593 & 601-603 Laurier Avenue West

UDRP REPORT
Official Plan and Zoning By-law Amendment Applications
June 15, 2025

URBAN DESIGN BRIEF

601 LAURIER AVENUE

DESIGN EVOLUTION

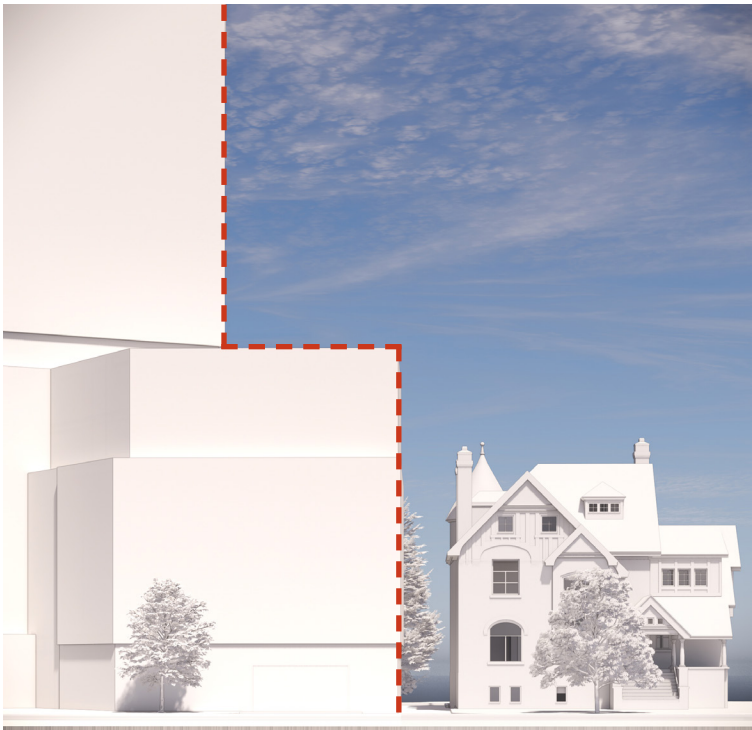
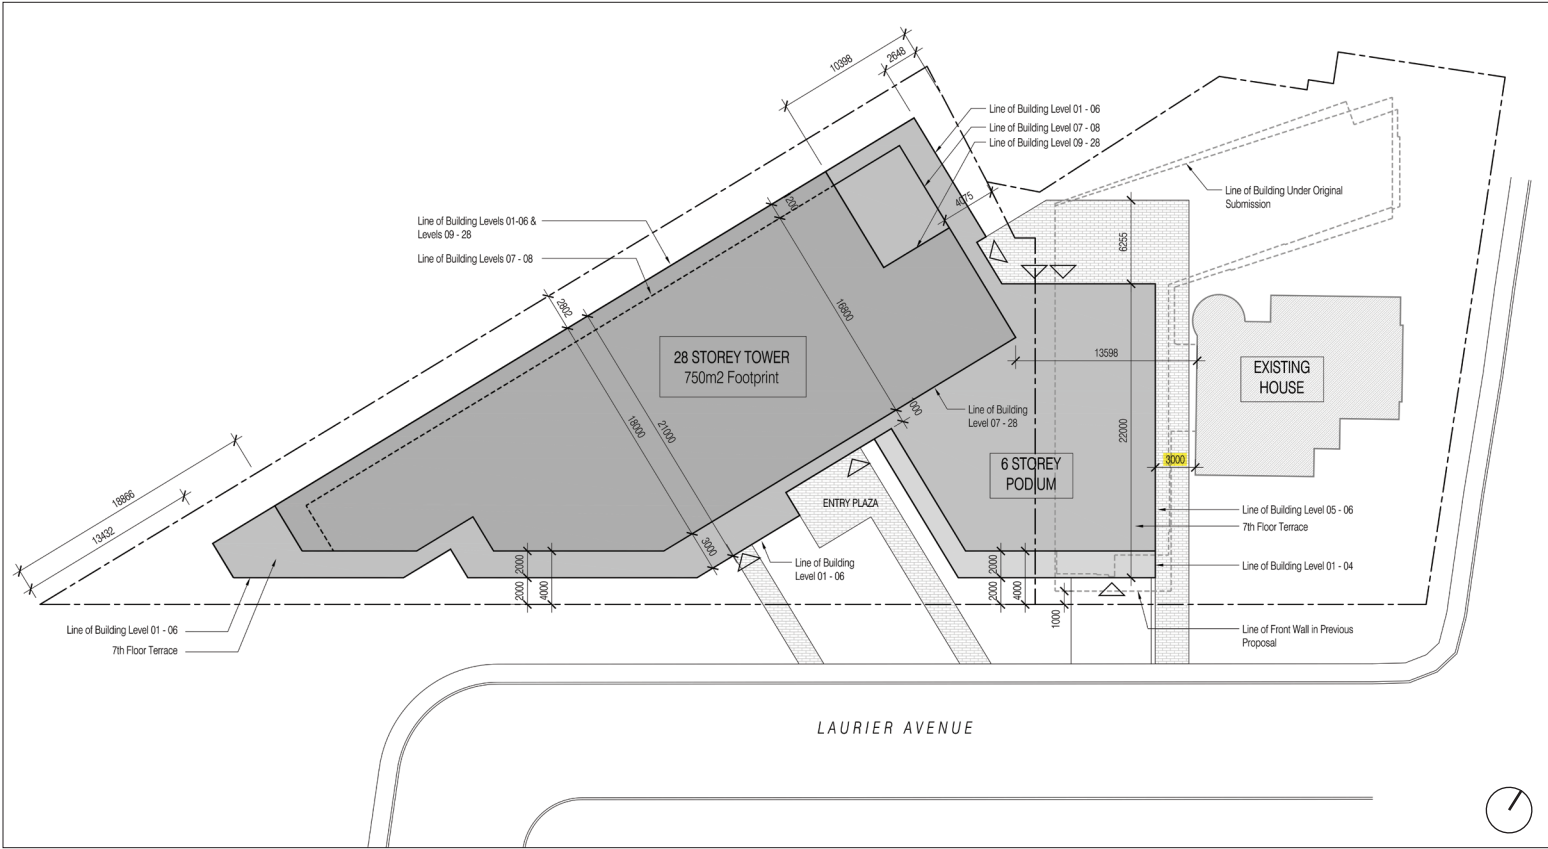
The podium may be high for the neighbourhood context and especially the relationship to the heritage house on the property. We recommend providing additional design/massing details so we may better understand the approach being taken.

We have increased the separation from the heritage house to 4.5m from 3m and introduced a setback and material change above level 4 to better integrate the podium with the neighborhood context. These adjustments help to mitigate the podium height and ensure a more harmonious relationship with the heritage house.

The initial massing concept positioned the proposed development 3 meters from the existing Heritage House for the first six storeys of the podium. This approach was primarily driven by the objective to maximize leasable space, providing ample room for residential units while maintaining vehicular access to essential building services at the rear. This configuration, however, raised concerns about the proximity to the Heritage House and its impact on both the historical context and practical access, and required further consideration to improve spatial dynamics and circulation.

In response to these concerns, the current design iteration has been refined to enhance both spatial and aesthetic relationships. The podium has been shifted an additional 1.5 meters away from the Heritage House, resulting in a total separation of 4.5 meters. Furthermore, levels five and six of the podium are now recessed an additional 1.8 meters, creating a more gradual transition to the tower levels above. The first four levels of the podium, which align with the height of the Heritage House, will feature red-tone brick complimenting the red brick of the existing structure. This material choice reinforces the architectural dialogue between the new and existing building.

Current Site Plan

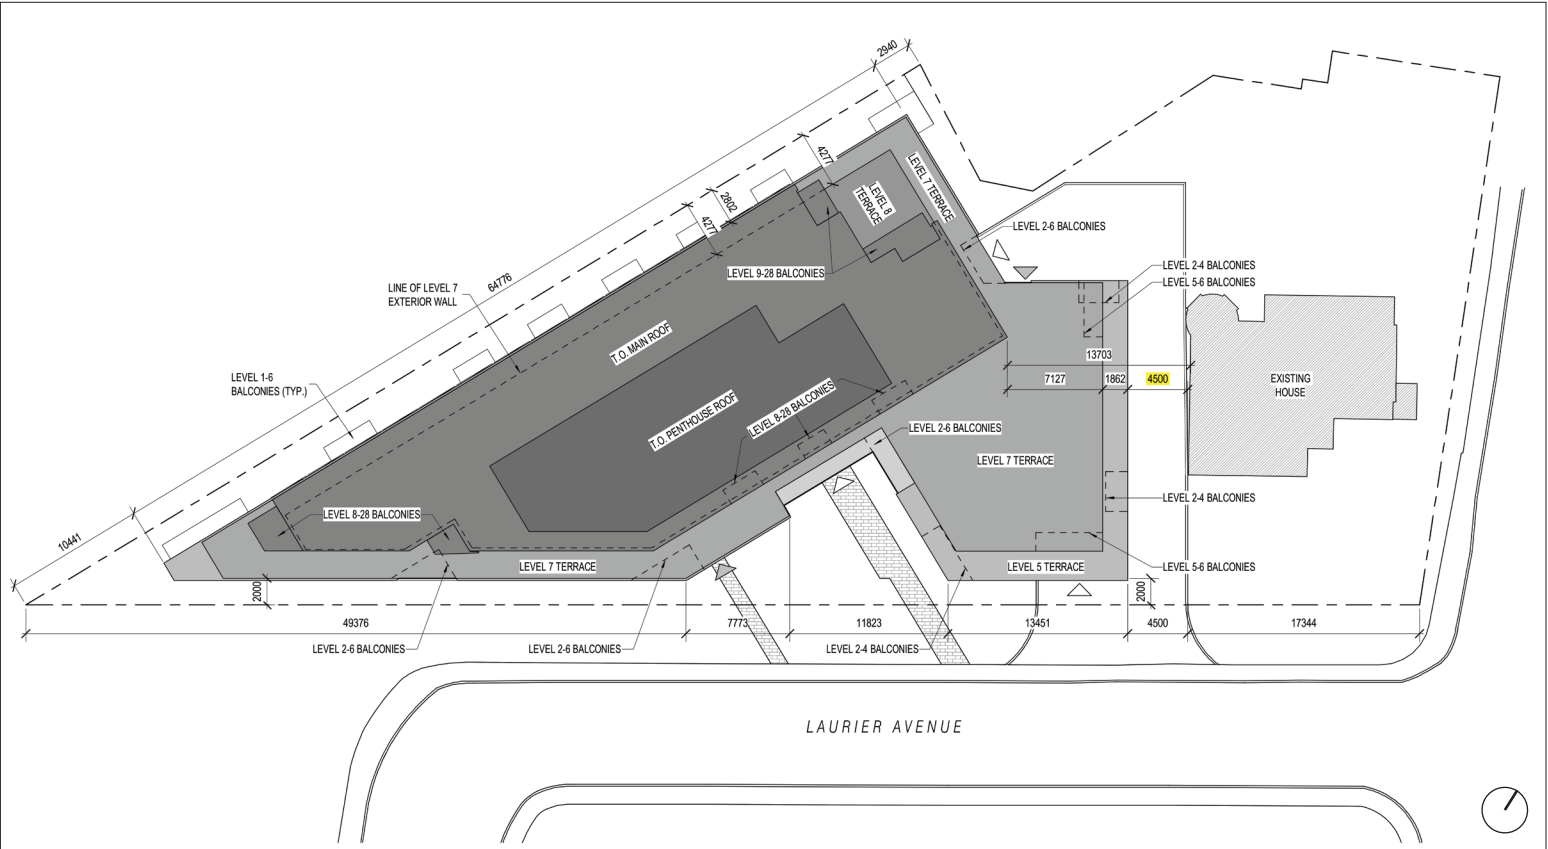
9.	The Panel has concerns that the curb cut for the parking and servicing driveway (approx. 11m) is quite wide, and recommends minimizing the curb cut as much as possible. The Panel recommends the hard landscaping of the driveway area be treated in a woonerf style.	We will work closely with our civil engineering consultant during the site plan control phase to refine the driveway details. We intend to minimize the driveway's impact by incorporating strategies such as pavers to soften the visual effect.

These adjustments not only facilitate improved vehicle passage but also achieve better visual alignment with the surrounding context, ensuring the new development seamlessly integrates with its urban environment while respecting the historical significance of the adjacent Heritage House.

West Elevation

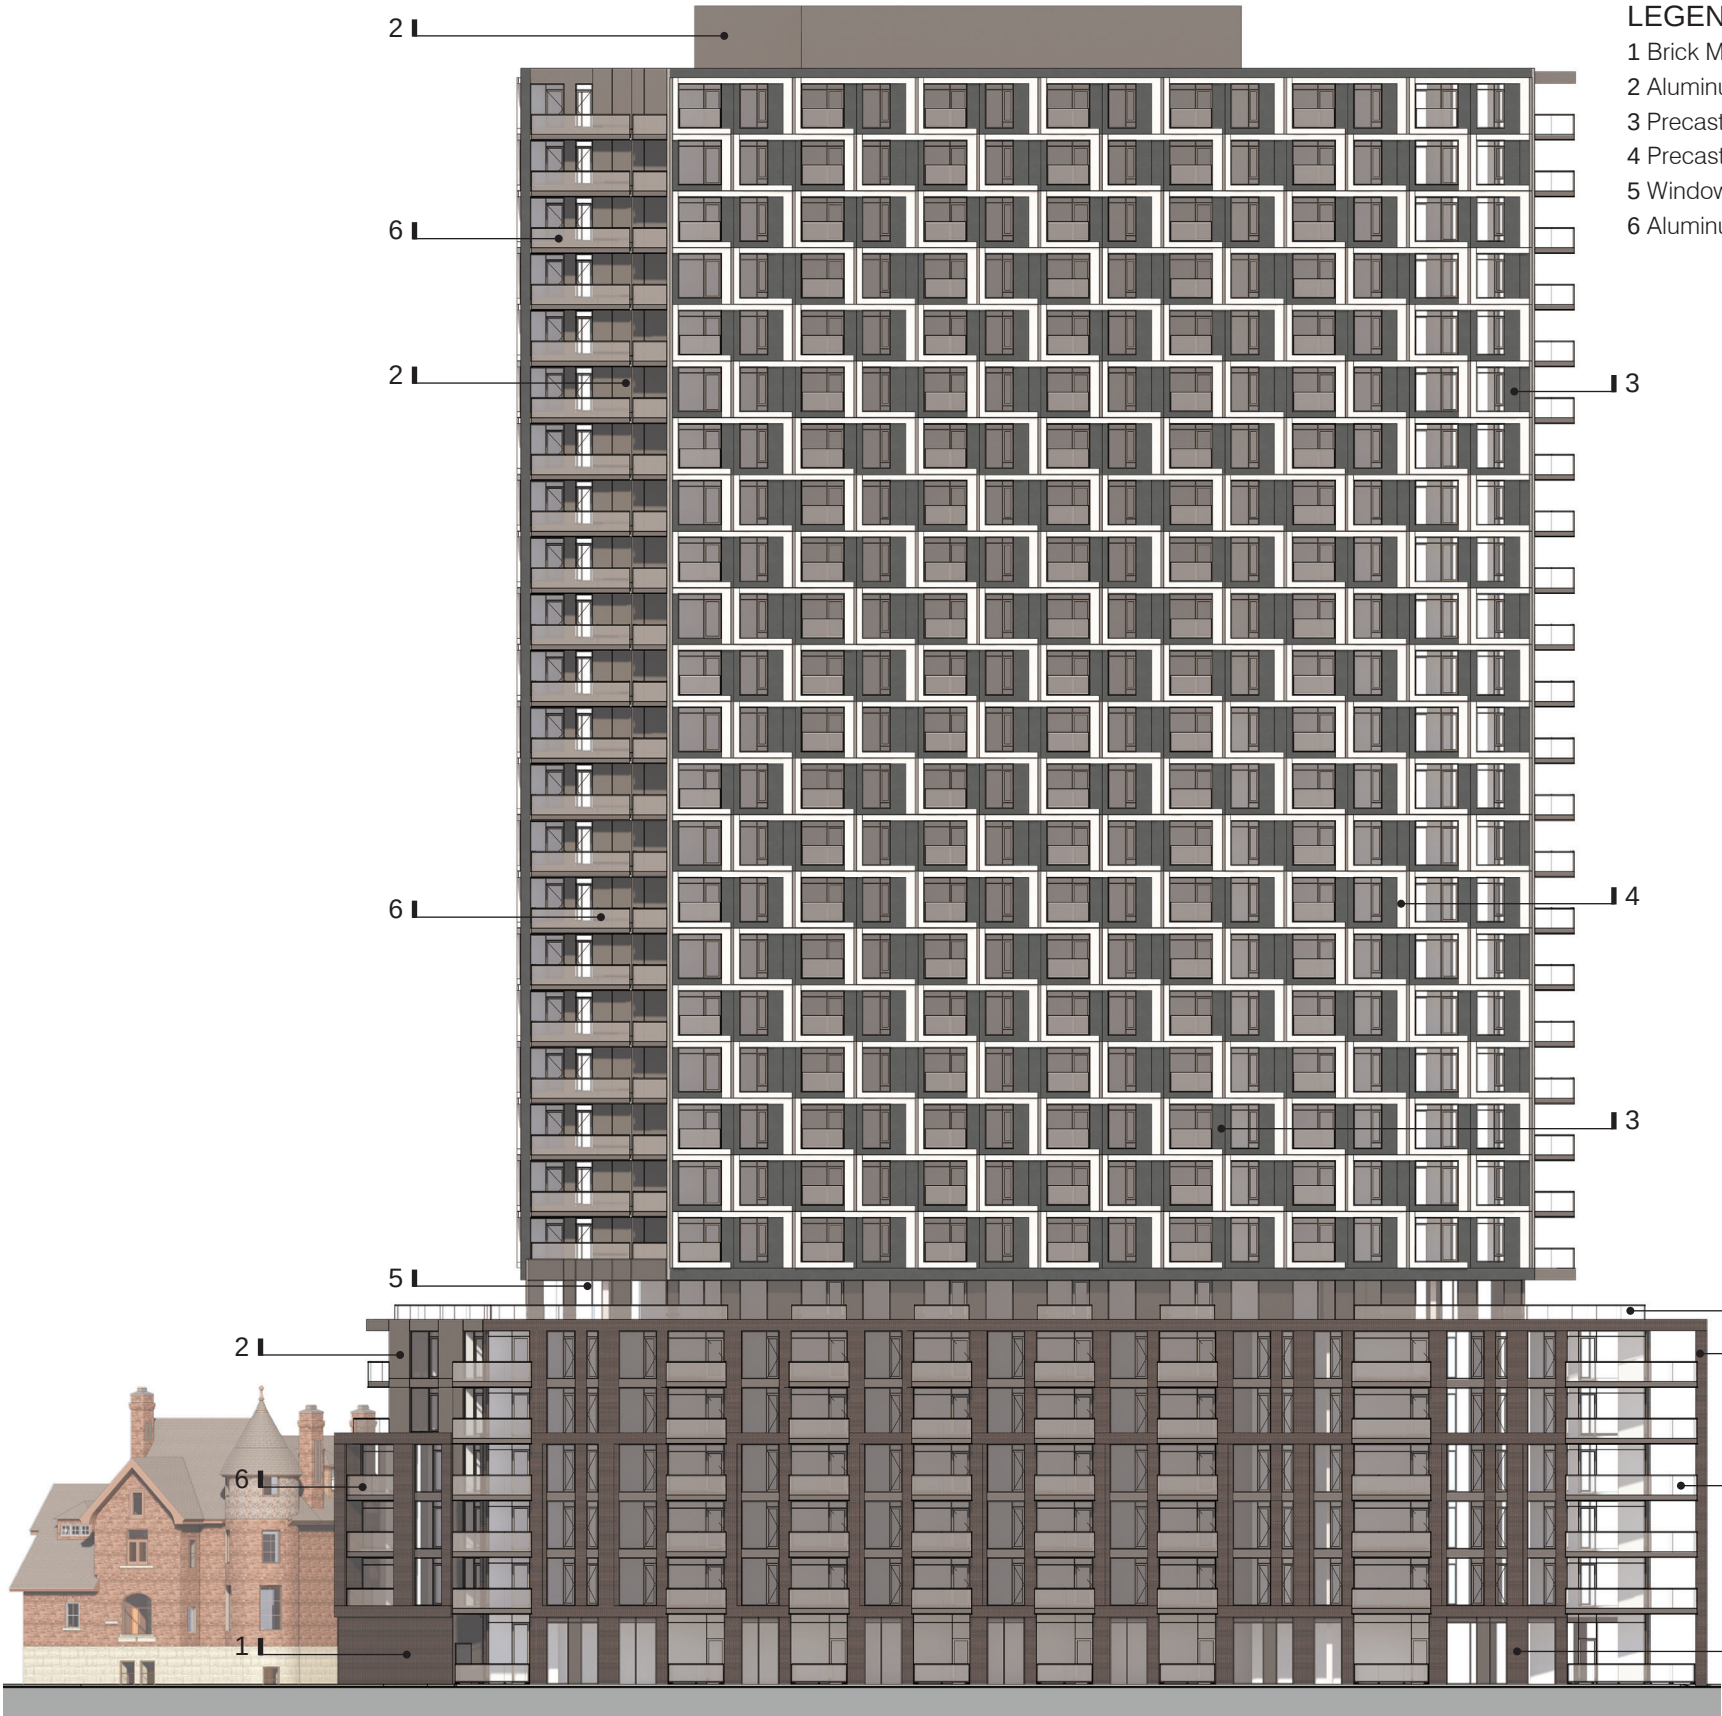
6.	The Panel has concerns with the width/expansiveness of the north/west elevation and provided a variety of suggestions to help visually reduce the apparent width of the west façade.	We understand the concern about the length of the elevation, and we are addressing this by incorporating reflective materials on the glass railings. This will help reduce the apparent width by introducing visual interest and dynamism to the elevation.
	Site Design & Public Realm

To address the risks of uncomfortable wind speeds on the upper stories facing west, the design incorporates glazed Juliette balconies. These balconies provide access to fresh air and outdoor views without adding the bulk and impracticality of larger balcony spaces. On the east side, recessed balconies offer sheltered outdoor spaces, enhancing the living experience for residents.

FIGURE 9: TYPICAL USE PERIOD – WIND COMFORT, LEVEL 7 COMMON AMENITY TERRACE

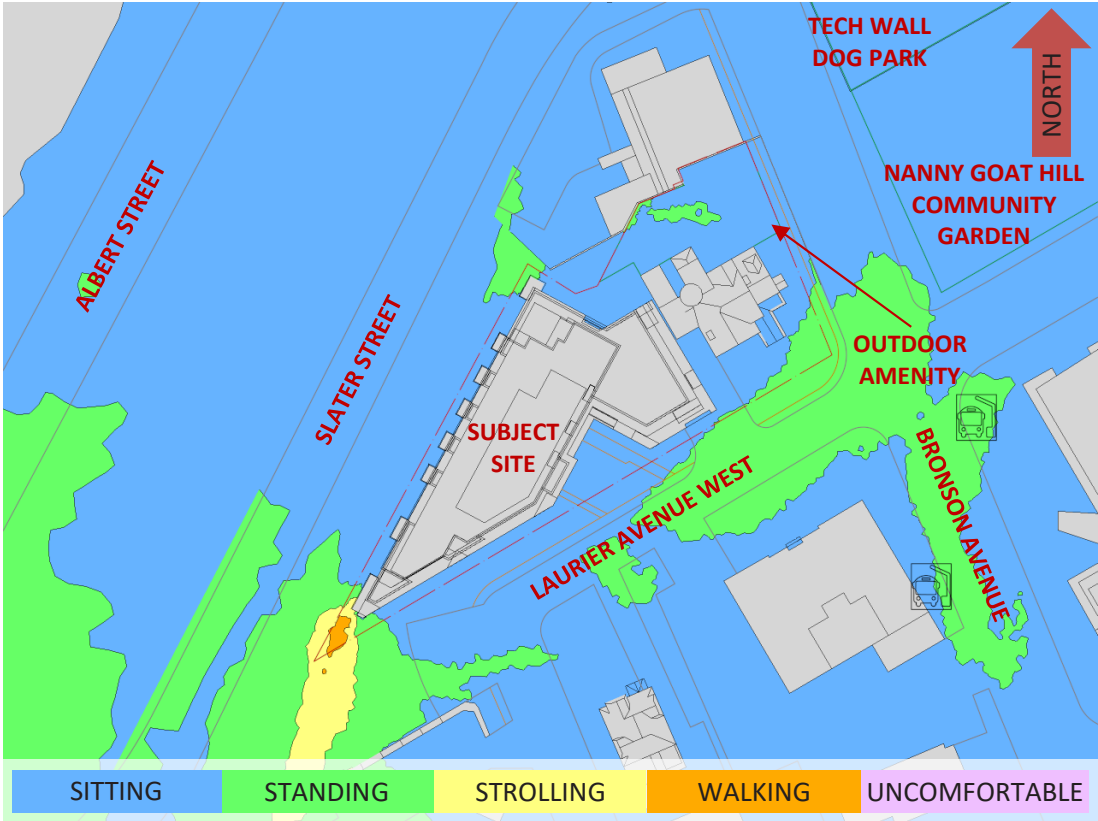
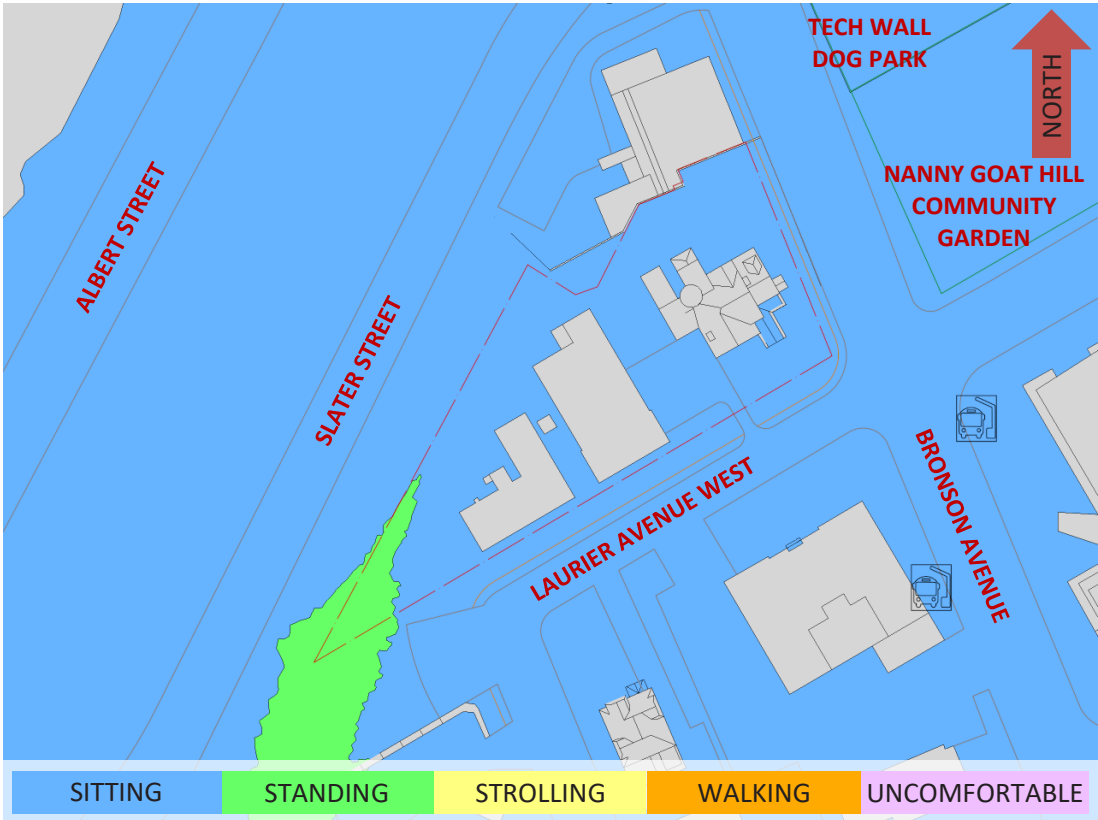
- c. When a wind and/or shadow studies are required please refer to the Terms of Reference for the wind analysis and shadow analysis to conduct the studies and evaluate the impacts.*
Noted. Please find the shadow analysis drawings at the end of the Design Brief.

As illustrated in Figure 9, wind comfort conditions within the common amenity terrace serving the proposed development at Level 7 are predicted to be suitable for sitting, which is considered acceptable. Notably, the Level 7 amenity terrace was modelled with 1.8-m-tall wind screens along its full perimeter.
